**19 WASHINGTON STREET
SHERBORN, MASSACHUSETTS 01770**

**RE: Draft Phase III Remedial Action Plan
General Chemical Corporation (GCC)
133 Leland Street, Framingham, MA
RTN 3-19174
ACO-NE-14-3R001**

The Town of Sherborn (Town) Board of Selectmen (BOS) respectfully submits the following comments regarding the GES Draft Phase III Remedial Action Plan Review dated February 15, 2016. GES prepared the Draft Phase III document on behalf of General Chemical Corp. (GCC) and Trinity General Corp. (Trinity) as required by the Massachusetts Contingency Plan (MCP) and the Massachusetts Department of Environmental Protection (MassDEP) pursuant to the existing Administrative Consent Order (ACO) ACO-NE-14-3R001, with an effective date of March 26, 2014.

Figure 1. Sherborn Wells Impacted by GCC Chemicals of Concern (COC)

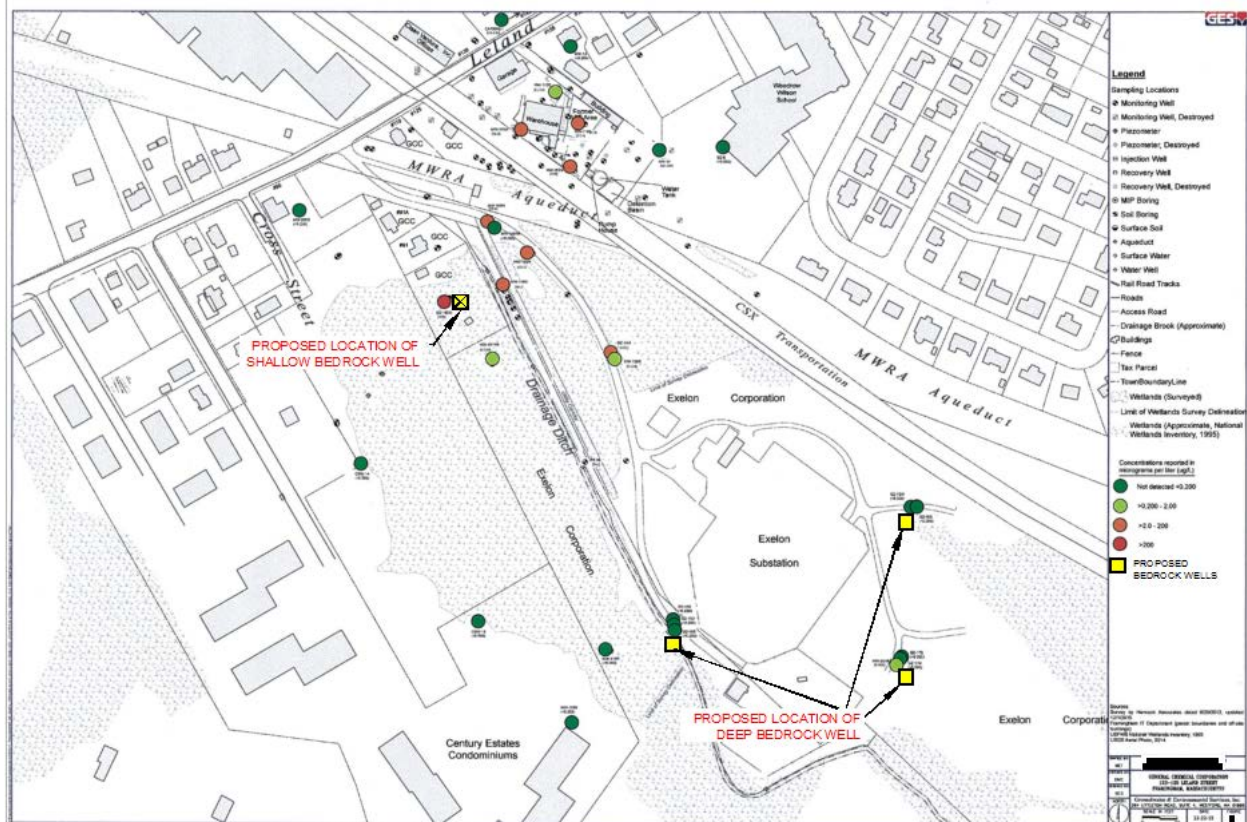
7. Potable private drinking wells in Sherborn are less than 300 yards downgradient from a bedrock monitoring well that exceeds GW-1 groundwater cleanup standards and the contamination has been rising since installation of the well (Sept., 2014). The proposed remedy does not include a plan to diminish or cutoff the source(s) of the contamination that impact the monitoring well or downgradient areas of Sherborn.

- 1) Install a bedrock well by GZ-19DD screened in the upper bedrock fractures to determine whether contamination in the lower overburden has impacted the groundwater. This bedrock well would help provide the necessary data connecting the GCC contamination of the bedrock and the contaminants identified in the Sherborn potable wells.

- 2) Install three deeper (perhaps 50 to 75 feet into bedrock) bedrock sentry wells (continuously cored) in the Town of Framingham (Figure 1) to provide early warning, easy access and characterization of deeper bedrock impacts. Conduct geophysical, hydrologic and chemical testing of these sentry wells to identify fracture networks, high flow zones, chemical properties for assessing partitioning values to determine chemical retardation and diffusion and contaminant concentrations. Install the well screens at the depth of highest contamination and flow rate in the bedrock. The well locations were chosen to be near multiple existing wells so that flow gradients can be determined between the various stratigraphic units.
